Addendum No. 2

Twin Falls School District Harrison and Morningside HVAC

ADDENDUM NO. 02

Project Name: TFSD Harrison HVAC Replacement
Address: Twin Falls, Idaho

Sheet No:
A9.01

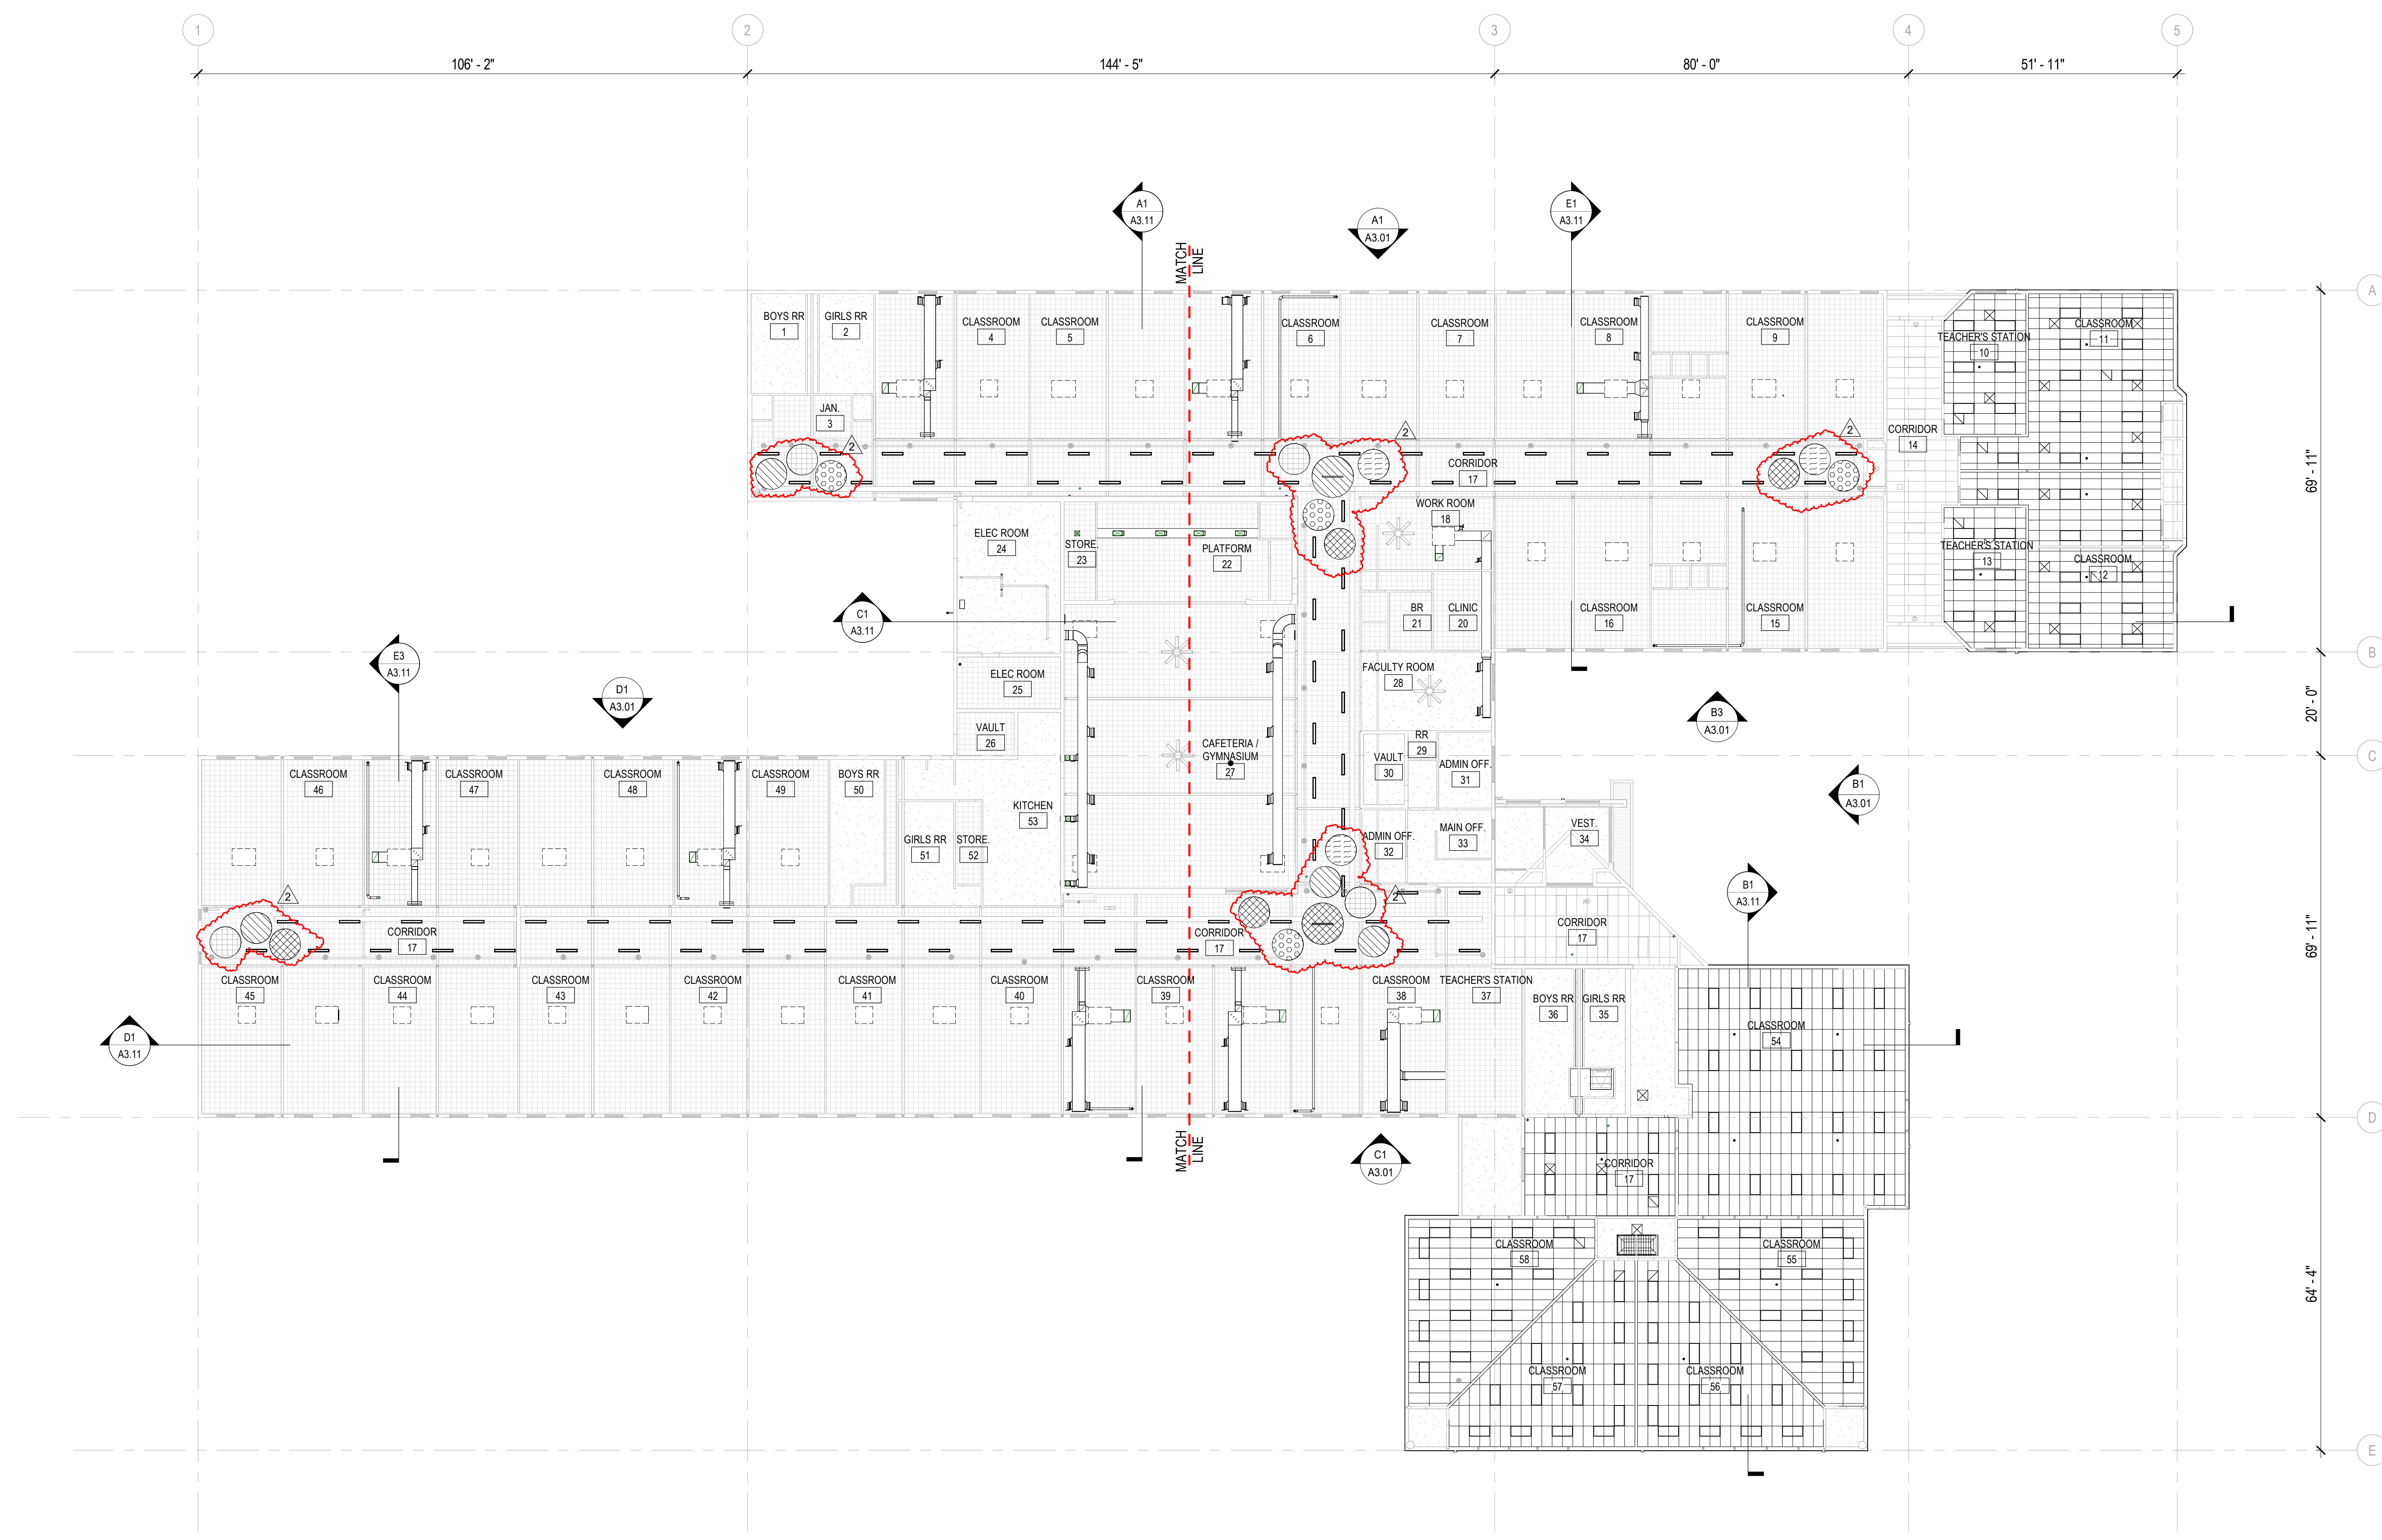
- **A9.01 – COMPOSITE CEILING PLAN**
 1. Change 4'-0" ceiling cloud to 6'-0" ceiling cloud
 2. Update ceiling grids from 2'-0" x 4'-0" grid to 2'-0" x 2'-0" grid.
- **A9.11 – AREA 'A' CEILING PLAN**
 1. Change 4'-0" ceiling cloud to 6'-0" ceiling cloud. Update dimensions and locations of ceiling clouds.
 2. Update ceiling grids from 2'-0" x 4'-0" grid to 2'-0" x 2'-0" grid.
- **A9.12- AREA 'B' CEILING PLAN**
 1. Change 4'-0" ceiling cloud to 6'-0" ceiling cloud. Update dimensions and locations of ceiling clouds.
 2. Update ceiling grids from 2'-0" x 4'-0" grid to 2'-0" x 2'-0" grid.
